CITY OF ALBUQUERQUE

**RE: Lot 12 Block 10 Volcano Cliffs Unit 22 SAD 228
6304 Petirrojo Rd. NW
Grading and Drainage Plan Date: 3/5/2023
Rev. Engineers Stamp Date: 5/13/2023 (D10D003F12)**

<div>ENGINEER'S SEAL</div> <div></div> <div>5/13/23</div>	<div>LOT 12 BLK 10 UN 22 VC</div> <div>6304 PETIRROJO</div> <div><div>GRADING AND DRAINAGE PLAN</div><div><div><div>Rio Grande Engineering</div><div>PO BOX 93824 ALBUQUERQUE, NM 87199 (505) 321-9099</div></div></div></div>	<div>DRAWN BY DEM</div>
		<div>DATE 5-12-23</div> <div>6304 Petirrojo.DWG</div>
<div>DAVID SOULE P.E. #14522</div>		<div>SHEET # C1</div> <div>JOB #</div>

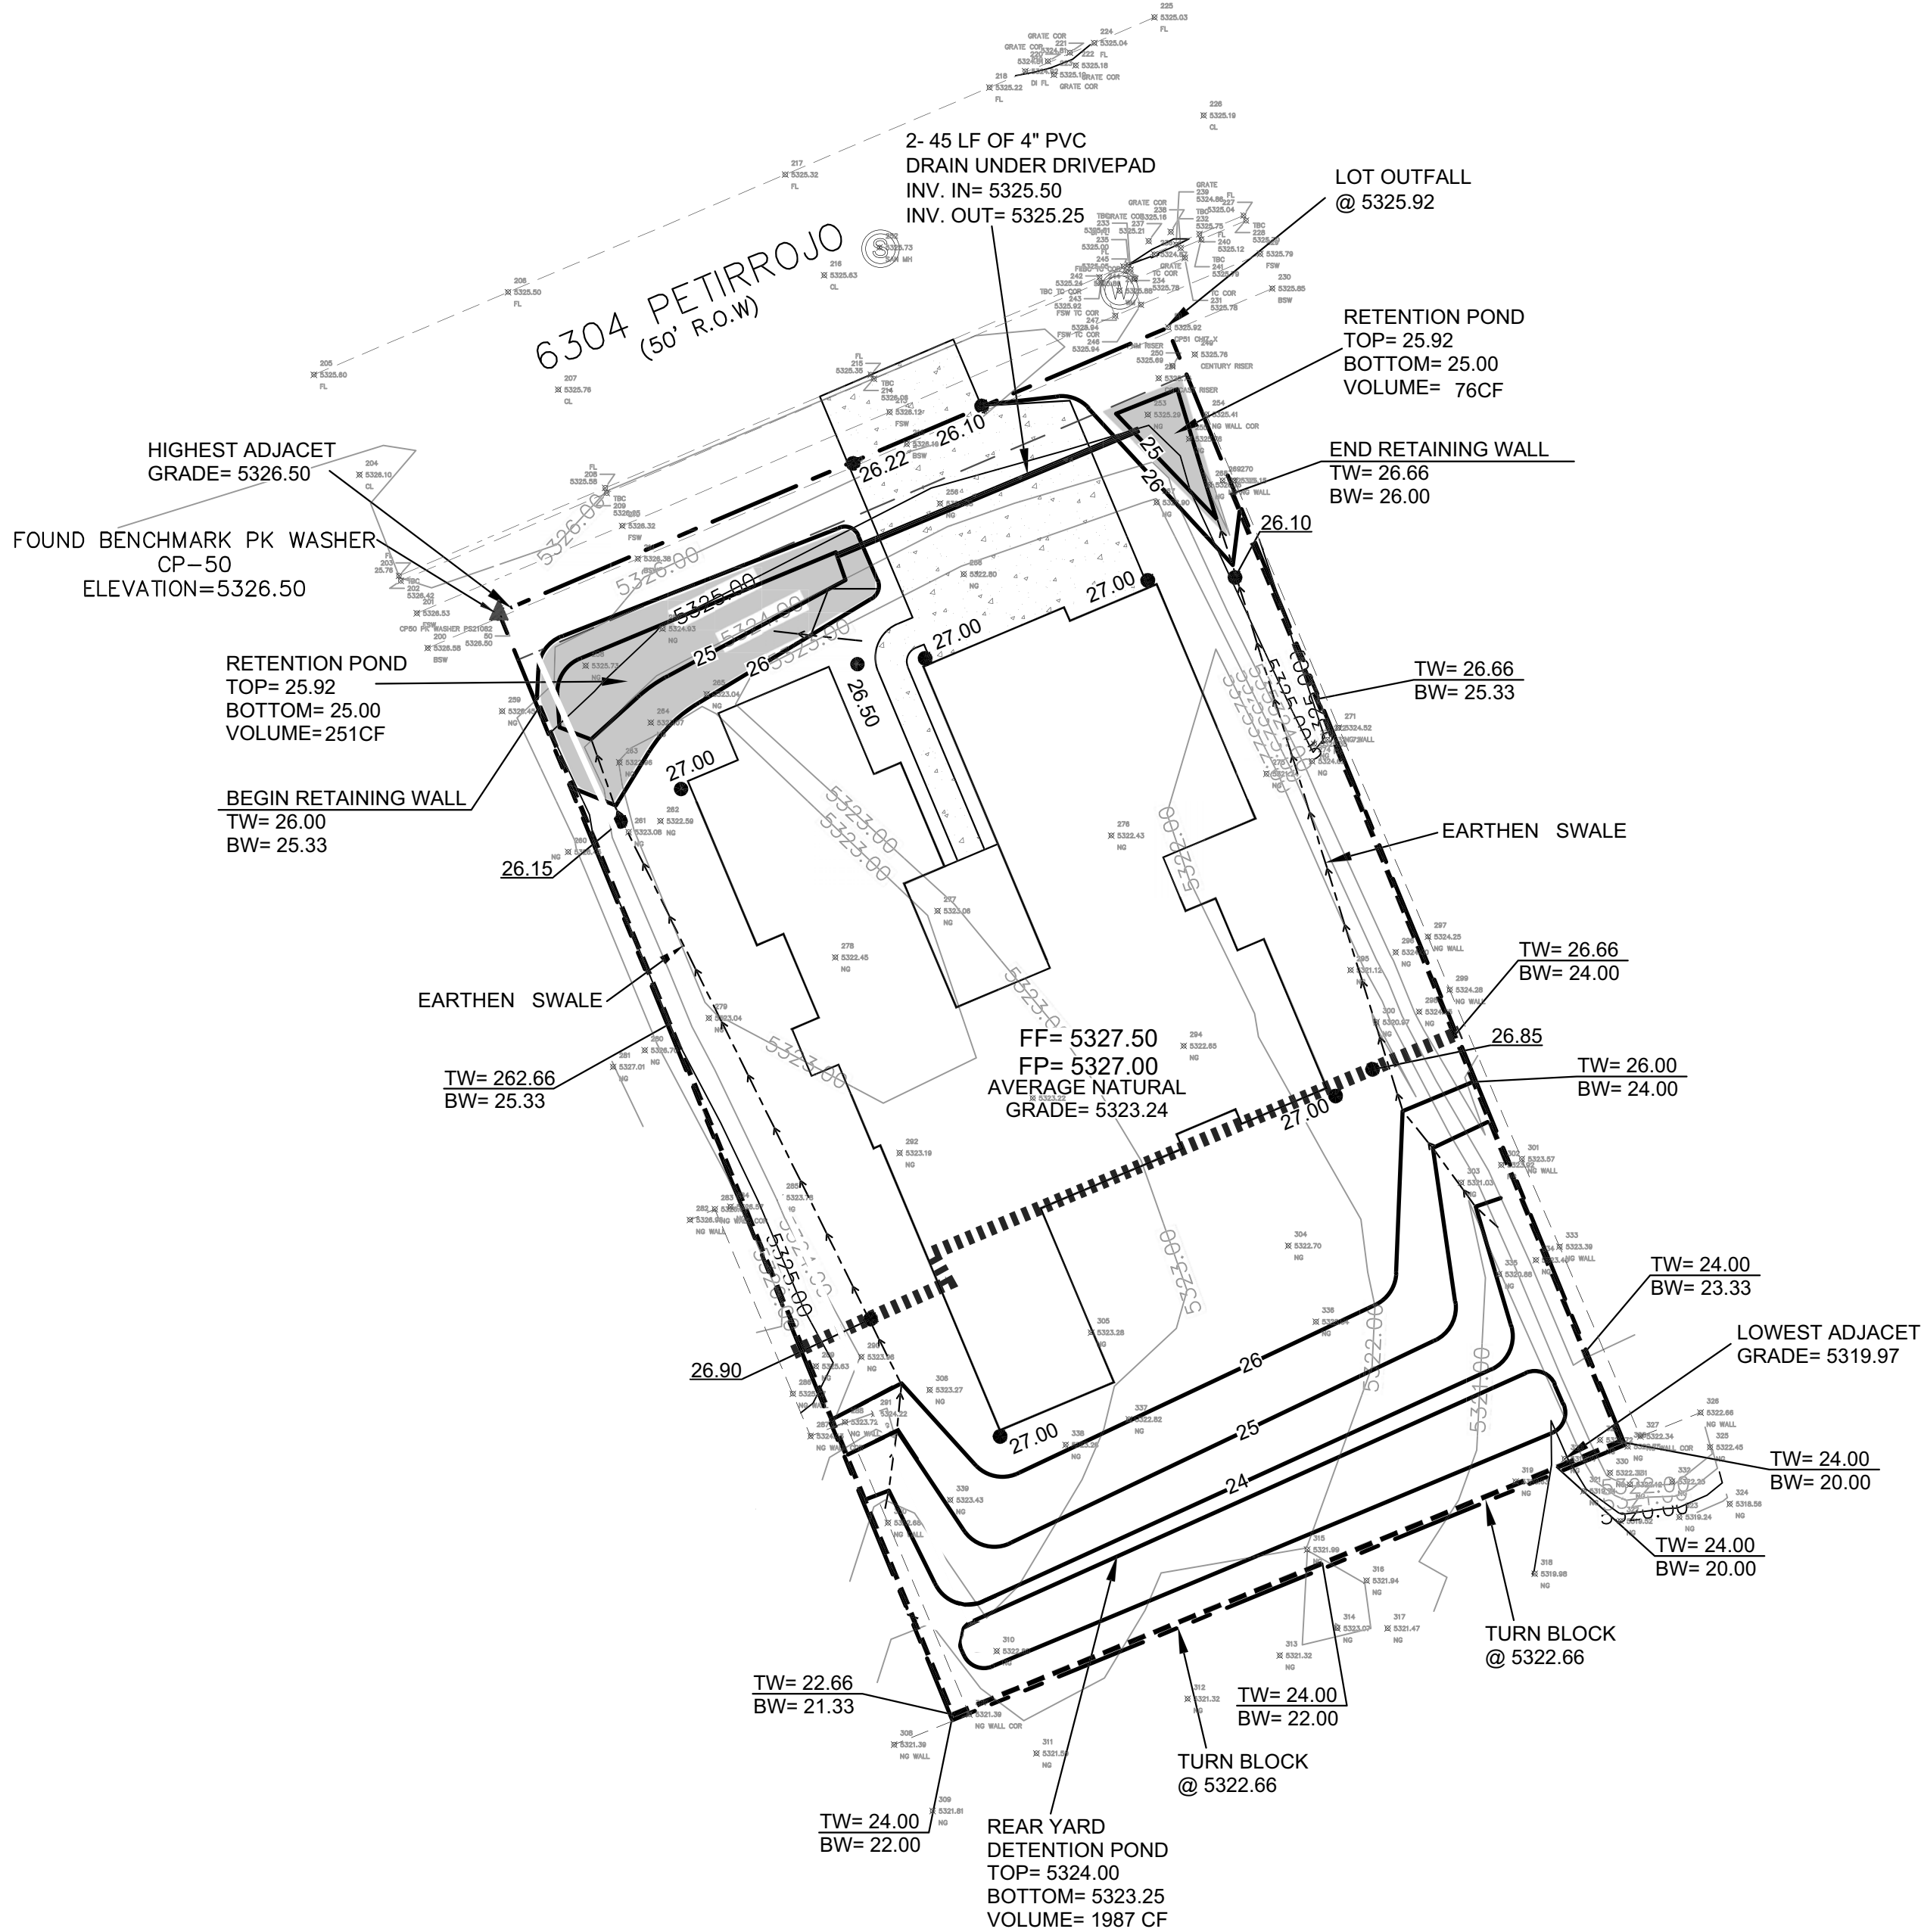
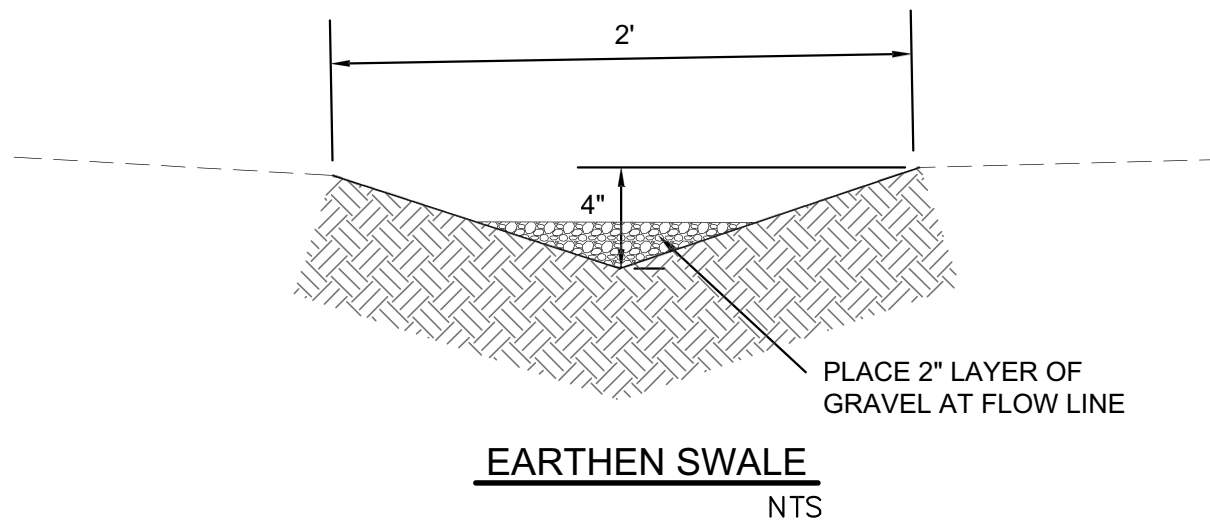
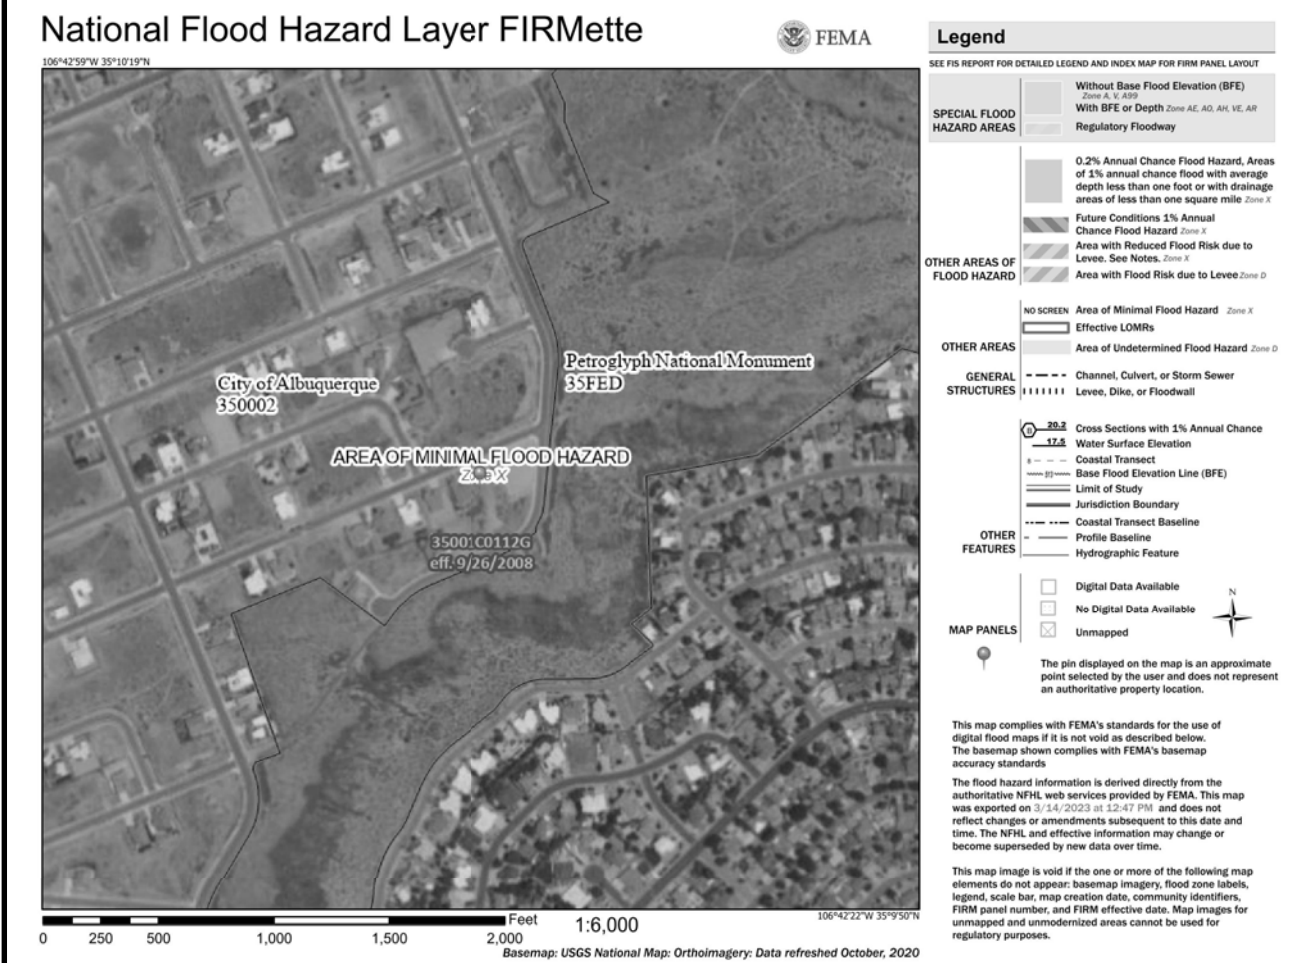
Based upon the information provided in your submittal received 5/25/2023, this plan is approved for a revised Grading Permit and building permit. **Dirt is not allowed to climb the curb, use crusher fines or lumber for this purpose.**

Prior to Building permit approval, a Pad Certification will be required, provided by the Engineer or a registered Land Surveyor.

Reiterate to the Owner/Contractor that a separate permit for a garden/retaining wall must be obtained, with the approved G&D plan.

Prior to Certificate of Occupancy release, Engineer Certification per the DPM checklist of this plan will be required.
